CONSERVATION COMMISSION

August 25, 2023

Re: Case # 2023-01,02,03 Rashid South Street Gas Station project MapLot 043-020-002

Variance for Prohibited Use of a Gas Station (underground storage of liquid petroleum product) located in the Groundwater Protection Area (Z.O. 6.01.3.B.7)

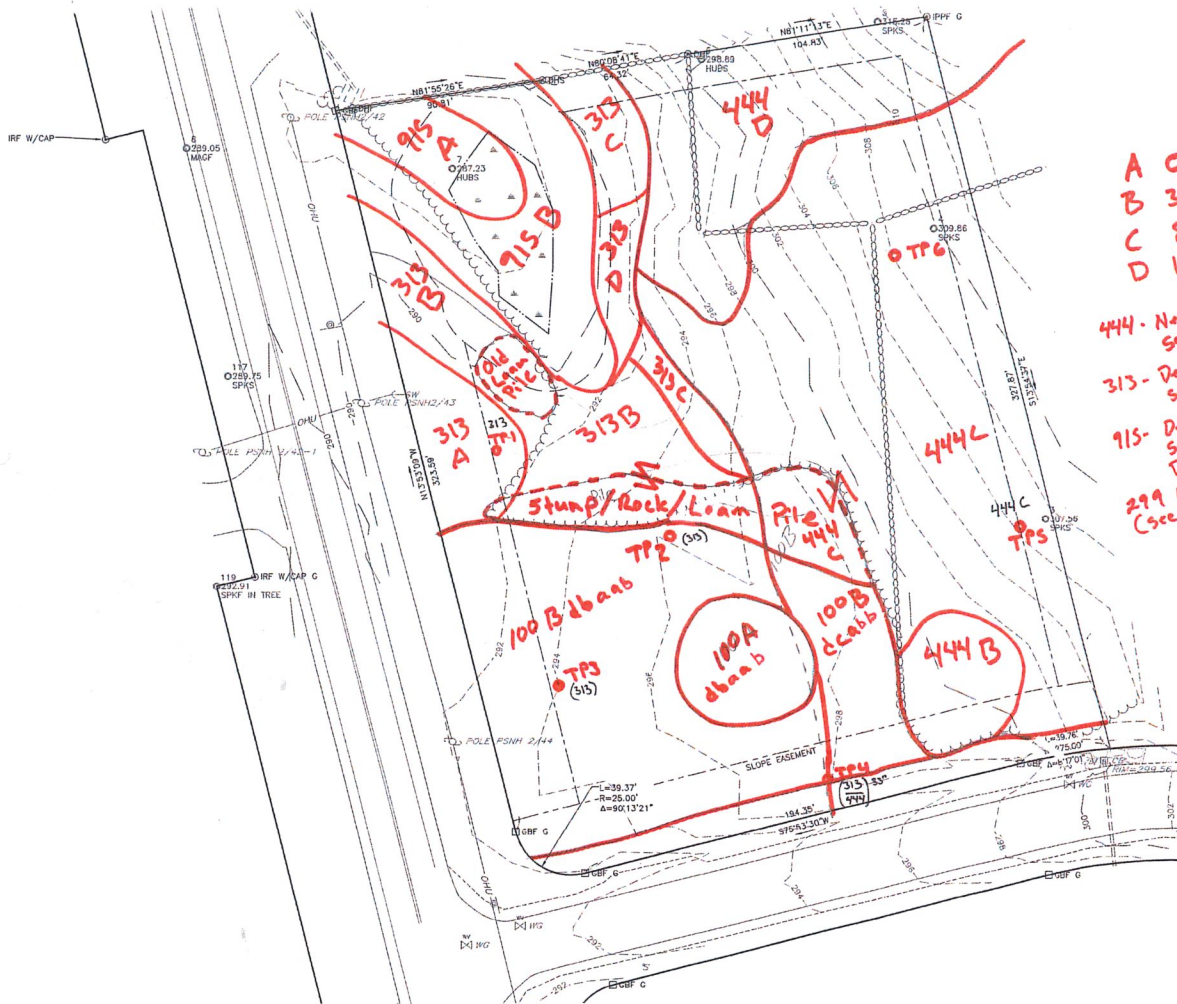
- a. The construction of Nathaniel Drive was not properly permitted nor designed to manage stormwater. The applicant is planning to use this parcel, Map 43-20-2, to mitigate the stormwater impacts from Nathaniel Drive. This could be an appropriate impact on the natural resources of this parcel, but not with the included ecosystem impacts of a gas station located over highly transmissible soils.

- a. To date, the applicant has not offered any mitigation measures other than to "use the latest technology". They cannot provide a 100% guarantee that the tanks will not leak.

- b. The MCC would like the ZBA to require a subsurface exploration of this parcel before rendering a decision concerning this request for a variance. The applicant needs to explore the site to understand the surface and subsurface hydrology of this parcel.

- i. The applicant should know the seasonal high groundwater level on the site and determine if there is a gradient, which will show how and where water or a pollutant will move across the parcel from the storage tanks and the pump area.

- ii. Initially, the applicant should drill a 4" hole at the minimum down to the water table,. And then go deeper at least to below the depth of the tank placement. Holes should be dug, at the minimum, where the tanks are going to be placed and at what is suspected to be down gradient from that location. More holes will tell a better hydraulic story.

1. We found seasonal water table from 19" to 51" (see test pit logs)
2. We dug down between 5' and 6' and found mainly sand. (see test pit sketch)
3. Proposed gas tanks would have a bottom depth of about 8 to 12 feet underground, so I guess there could be a clay layer below our test pits but with the seasonal high water marks I am still not sure what I could obtain from Borings at this point.
 - a. As we have said they would be double lined with alarms and all the modern bells and whistles.
